NON-COMPLIANCE REPORT # 31732-15

PART NAME: SLIDE SUPPORT ASSY
PF/SA NO.: SA-391-805-51 R5
WORK ORDER NO.: 31732-15
VENDOR BT LASER

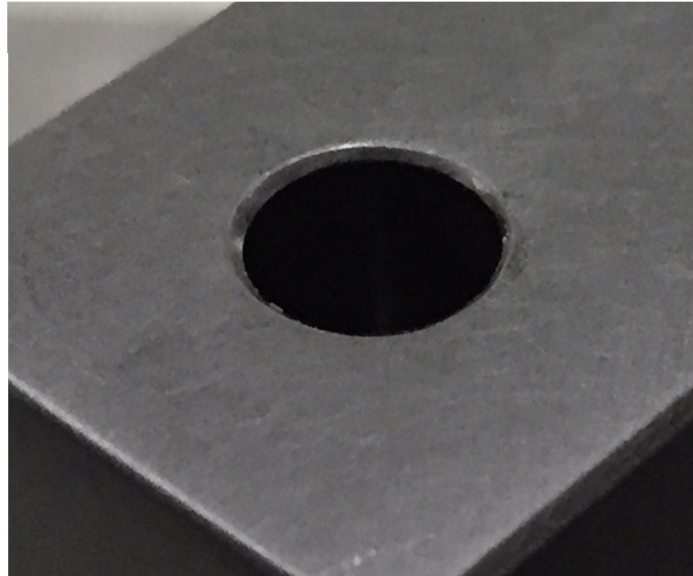
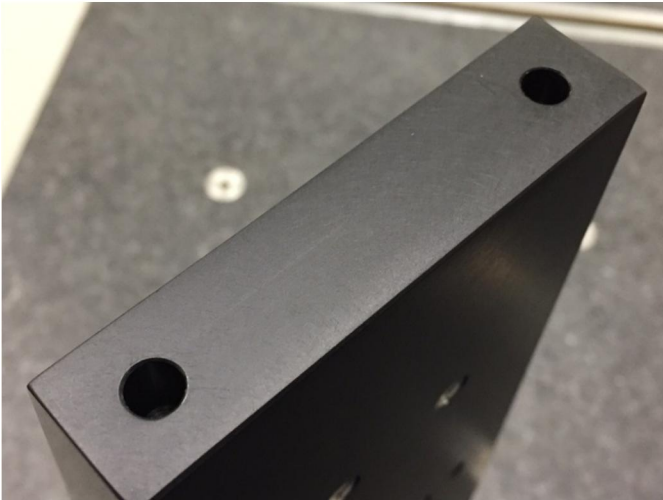
1. 2X $\varnothing .2501$ measures 0.2488 – 0.2490 on all parts.
 - The standard SLAC Metrology Tooling Ball (0.2498 Diameter) does not fit this undersized diameter.
 - Also, the holes seem to have the black anodized finish, this could cause the undersize diameter
